# Access Compliance Report

## Public Rights-of-Way

### (Curb Ramps)

Intersection ID: 21296	Main Street: E_ARROWOOD_RD	Cross Street: OLD_PINEVILLE_RD	Location: NE
ADA ID: 6019EB3AC282	Ramp Type: Perp	Initial Pass/Fail: Fail	Overall Compliance: No
		Severity Score: 12.5

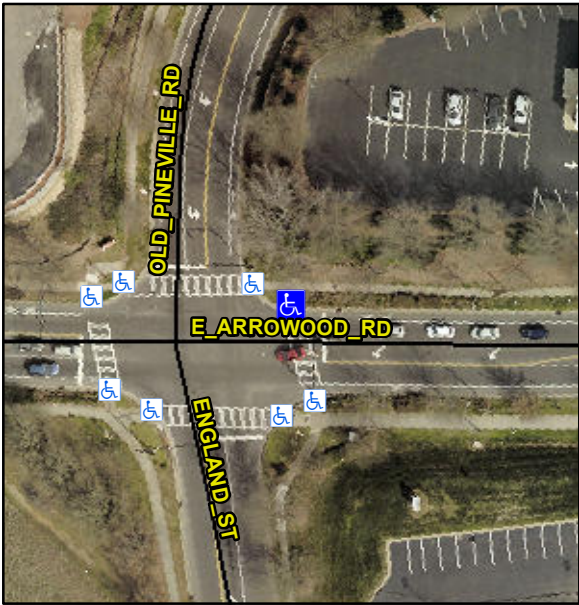
Codes/Mitigation Info/Possible Solution			Field Measurements/Component Compliance					
	Possible Solutions:		Compliance	Description	Data	Compliance	Description	Data
	Remove & Replace Entire Ramp.		N/A	Ramp Length (in)	104.0	No	Ramp Slope (%)	8.8
			Yes	Ramp Width (in)	69.0	Yes	Ramp XSlope (%)	1.4
			N/A	Flare Type LT	N/A	N/A	Flare Type RT	N/A
			N/A	Flare Slope LT (%)	N/A	N/A	Flare Slope RT (%)	N/A
			N/A	Flare Traversable LT?	N/A	N/A	Flare Traversable RT?	N/A
			N/A	Landing Length (in)	N/A	N/A	DWS Provided?	N/A
			N/A	Landing Width (in)	N/A	N/A	DWS Contrast?	N/A
			N/A	Landing Slope (%)	N/A	N/A	DWS Length (in)	N/A
			N/A	Landing X Slope (%)	N/A	N/A	DWS Full Width?	N/A
<p>Surveyor Notes:</p> <p>N/A</p> <p>PROW/ADA:</p> <p>Not Found, R304.2.2</p>			N/A	Landing Curb? (Y/N)	N/A	N/A	DWS Offset (in)	N/A
			N/A	Shared Landing?	N/A			
			N/A	Gutter Ponding?	N/A	N/A	Gutter Slope (%)	N/A
			N/A	Gutter Lip Ht (in)	N/A	N/A	Gutter X Slope (%)	N/A

N/A	Painted X Walk1?	Yes	N/A	Painted X Walk2?	N/A
				X Walk 1 Direction	To S		X Walk 2 Direction	N/A
			N/A	X Walk 1 Width (in)	114.0	N/A	X Walk 2 Width (in)	N/A
				X Walk 1 Slope (%)	4.5		X Walk 2 Slope (%)	N/A
				X Walk 1 X Slope (%)	0.0		X Walk 2 X Slope (%)	N/A
			N/A	Ramp inside XWalk1?	Yes	N/A	Ramp inside XWalk2?	N/A
			Road Slope (%)	N/A	N/A	Clear Space?	N/A	
			Road X Slope (%)	N/A	N/A	Clear Space to XWalk (in)	N/A	
		N/A	Any Obstructions?	N/A	N/A	Storm Grate/Utility Hazard?	N/A	
			Obstruction Type			Storm Grate/Utility Type		
					N/A			N/A
						Yes	Surface Condition? (G/P)	Good
